Revision History			
Title			
Size	Document Number	Rev	
A3	<Doc>	4.0	
Date:	Wednesday, January 30, 2008	Sheet	1 of 7

Project Name : BALBOA			
MSM6500			
File	Document Number	Rev	4.5
Size	480K		
Date	Wednesday, January 30, 2008	Sheet	4 of 4

Project Name : BAL80A	
File	CONNECTOR
Size A2	Document Number <Doc>
Date: Wednesday, January 30, 2008	Sheet 7 of 7
	Rev 4.5

UP_BOARD

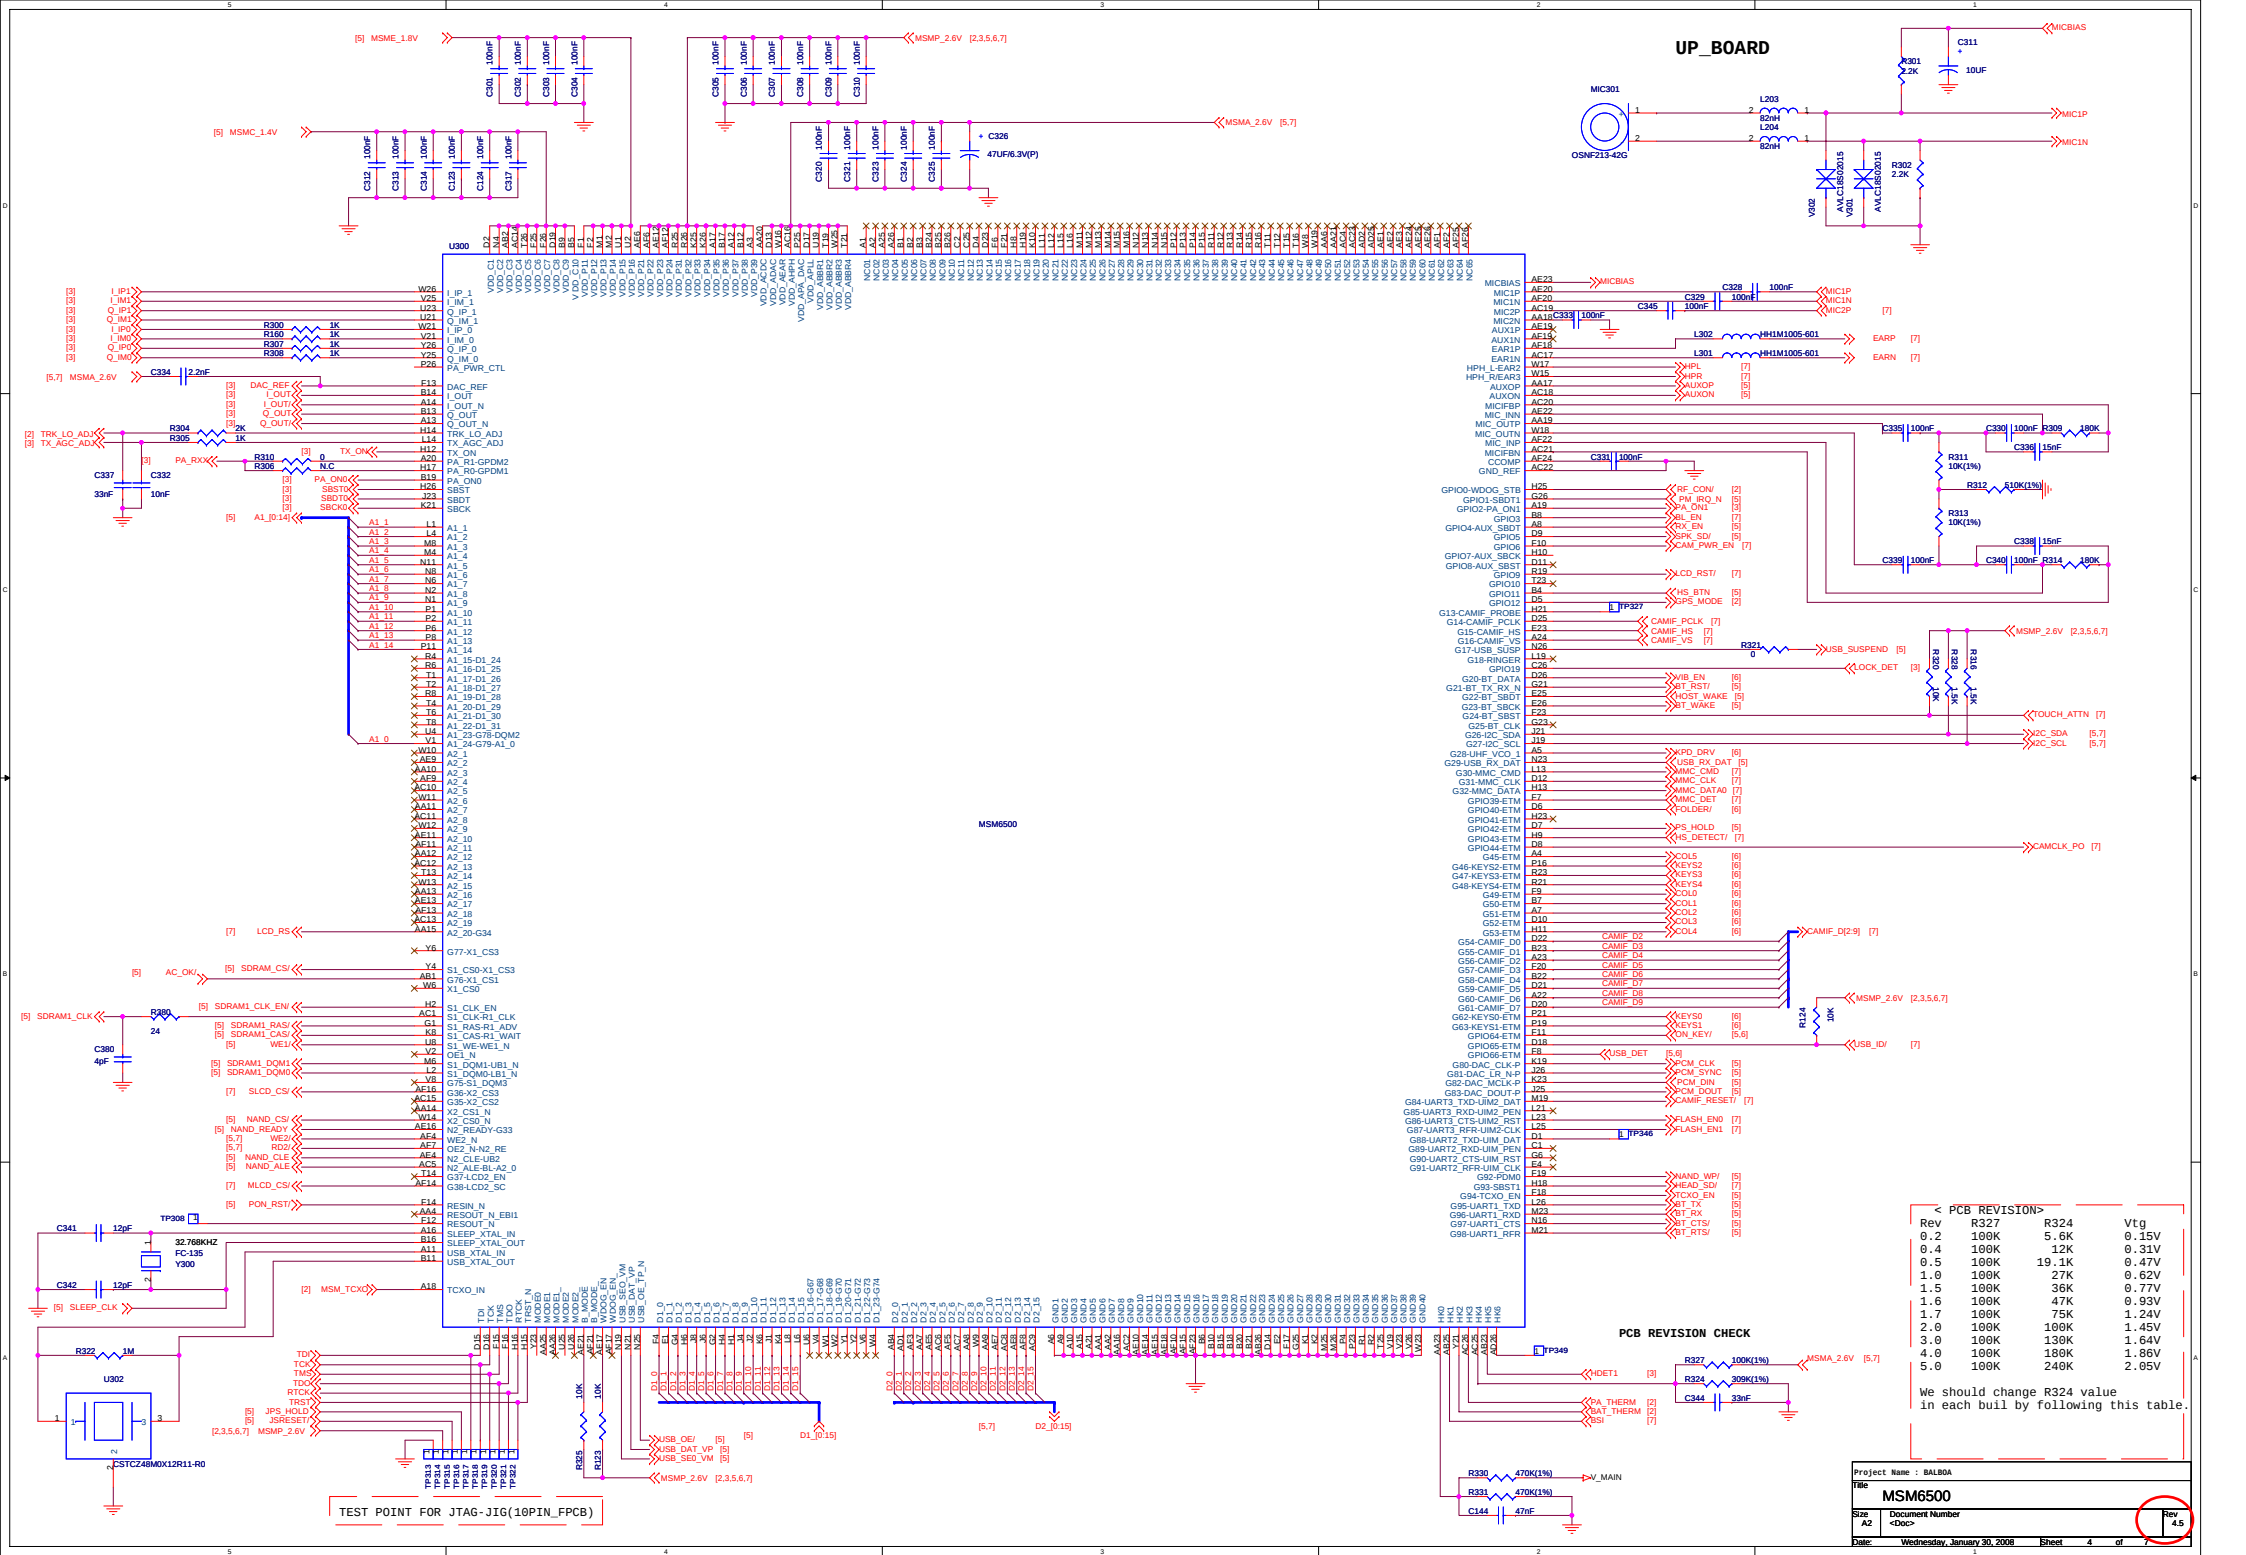
We should change R324 value in each build by following this table.

< PCB REVISION >				
Rev	R327	R324	VtG	
0.2	100K	5.6K	0.15V	
0.4	100K	12K	0.31V	
0.5	100K	19.1K	0.47V	
1.0	100K	27K	0.62V	
1.5	100K	36K	0.77V	
1.6	100K	47K	0.93V	
1.7	100K	75K	1.24V	
2.0	100K	100K	1.45V	
3.0	100K	130K	1.64V	
4.0	100K	180K	1.86V	
5.0	100K	240K	2.05V
